11-AFC-3

Cogentrix Quail Brush Generation Project - Docket Number 11-AFC-03: Hydrology Responses to Comments from Don Weston at the October 19, 2012 CEC Public Workshop

ADDITIONAL CLARIFICATIONS REGARDING ANALYSIS OF SOIL AND WATER IMPACTS

Correction to Figure 1-1-Project Vicinity Map

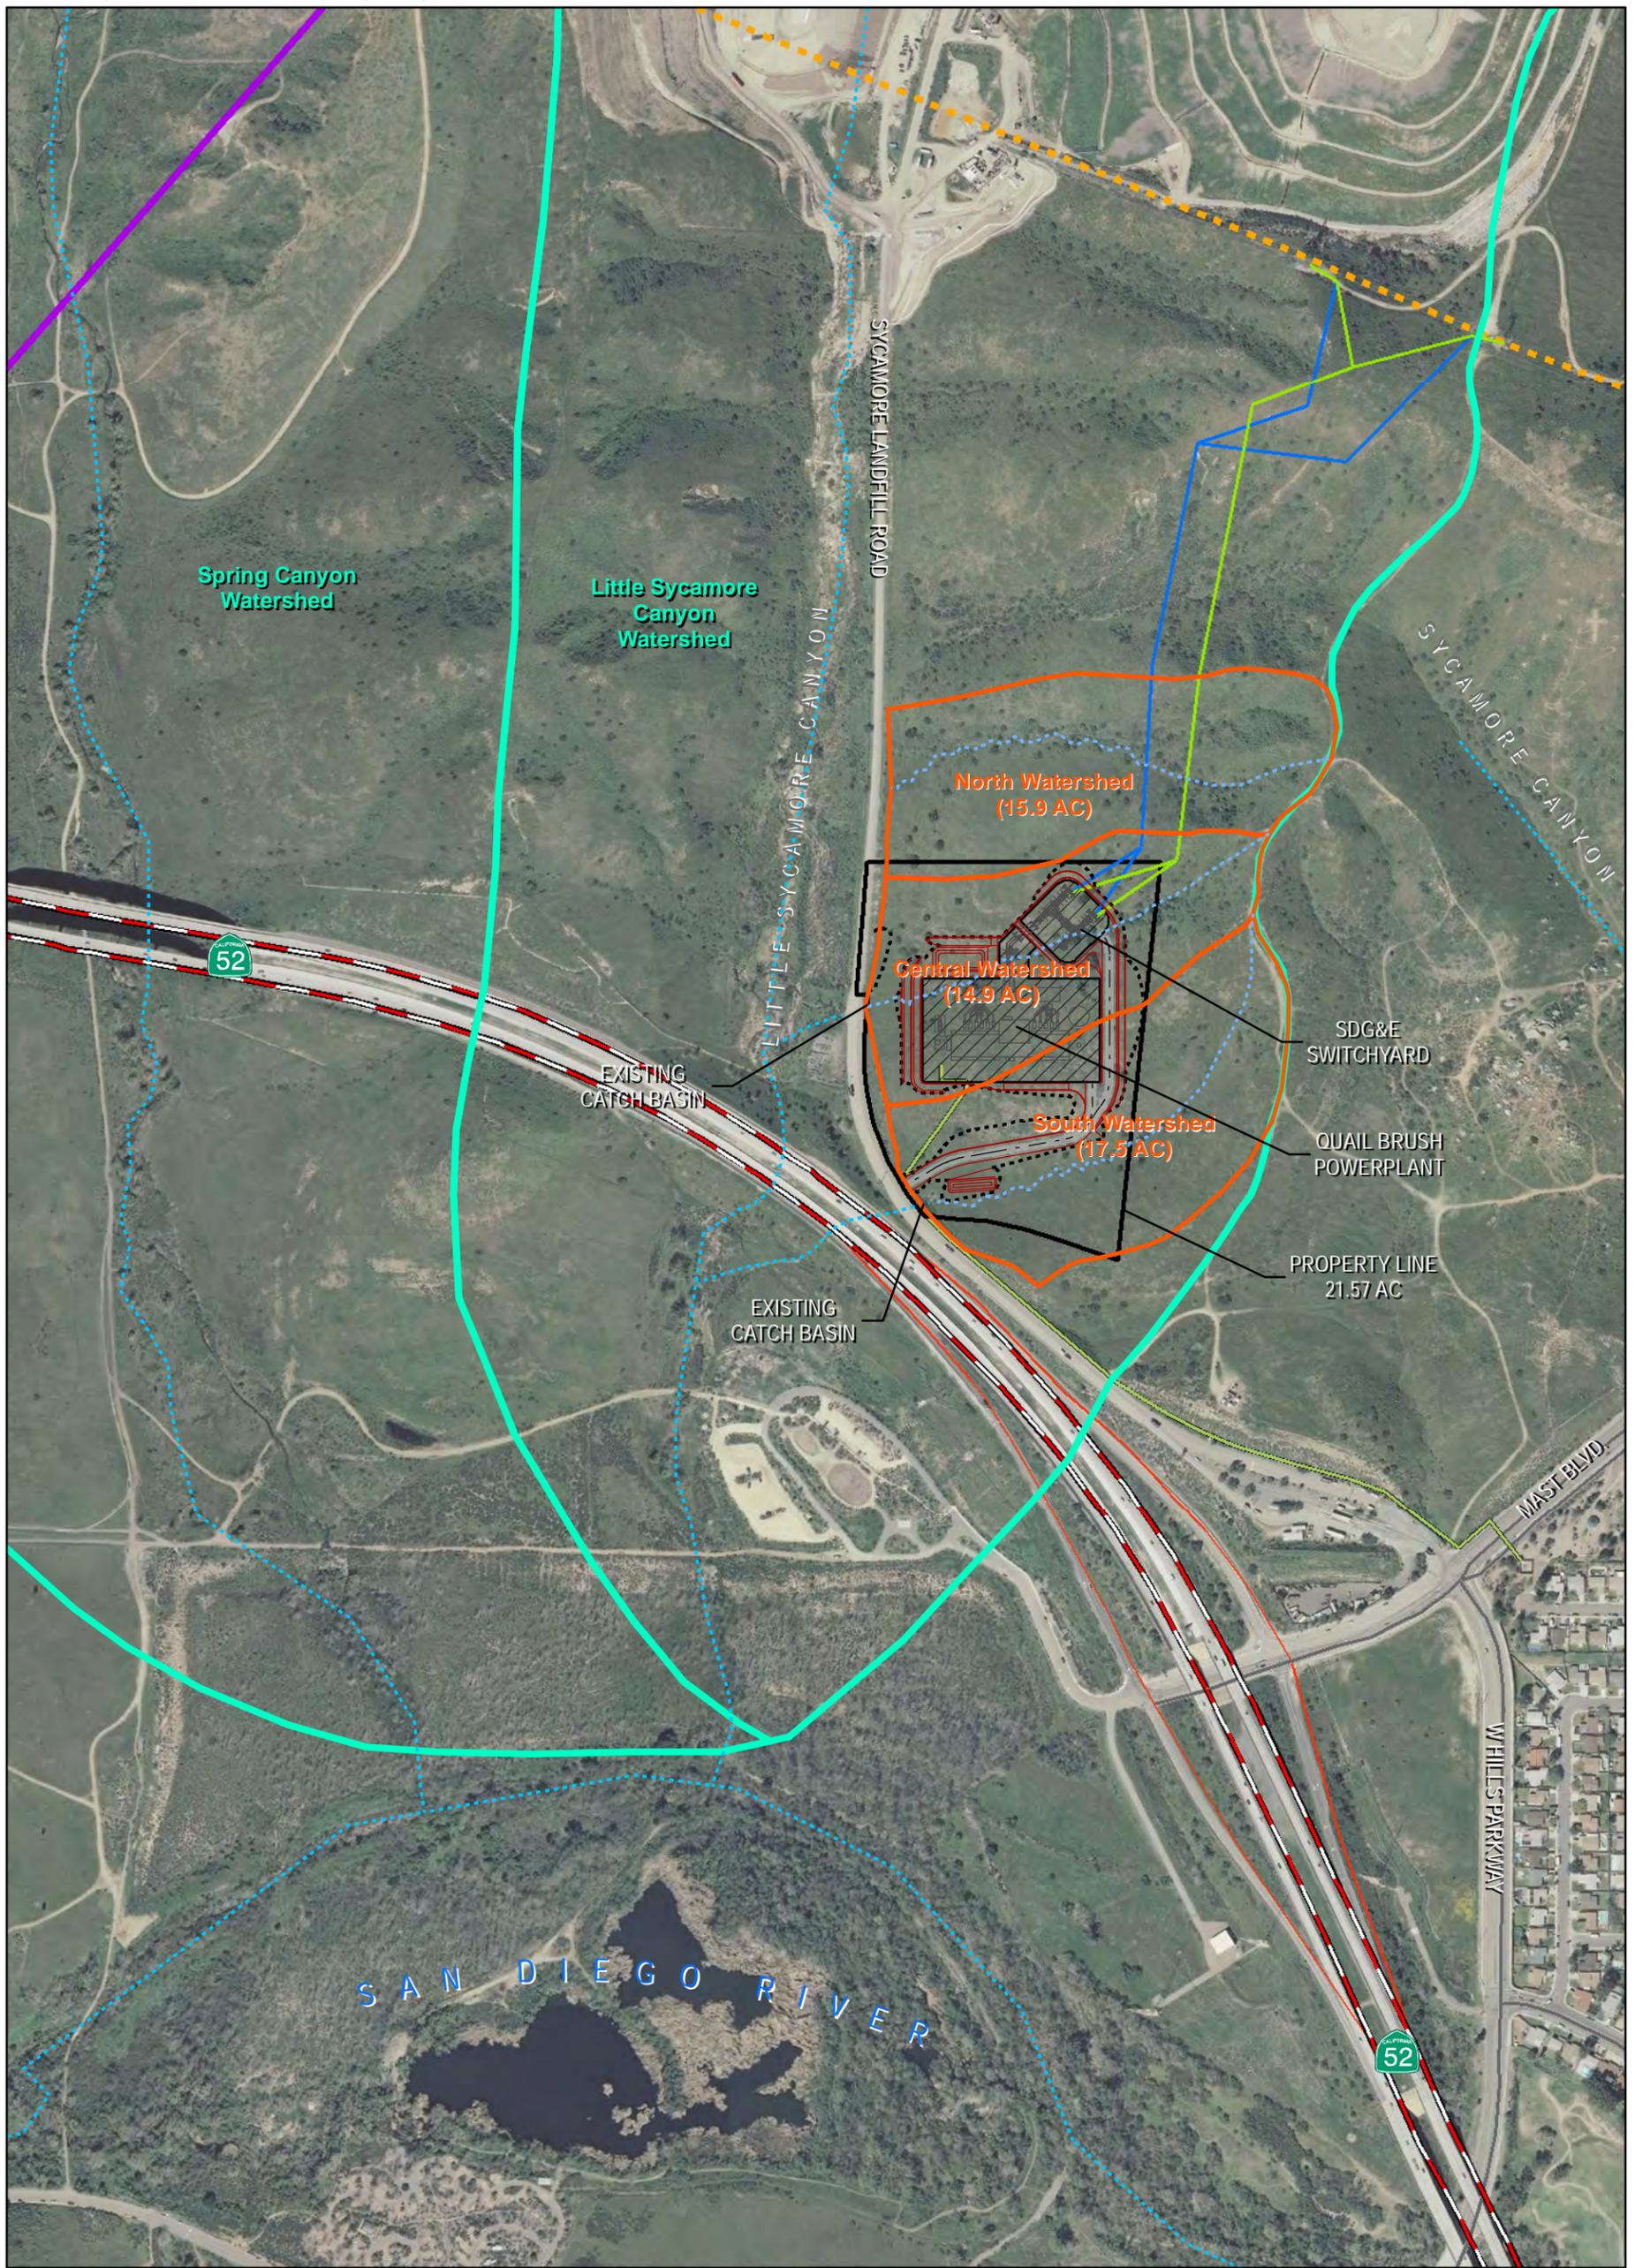
Due to a minor mapping inconsistency, a portion of the eastern Little Sycamore Canyon Watershed boundary shown in Figure 1-1 in the Water Quality Technical Report (Tetra Tech 2012b) does not agree with the sub-basin watershed boundaries. Figure 1-1 has been revised to correct the inconsistency in the figure and is attached. The Little Sycamore Canyon Watershed boundary plotted from data in a USGS database did not correctly identify the eastern ridgeline. The three sub-basin watershed boundaries were based on a recent digital terrain model of the Project vicinity.
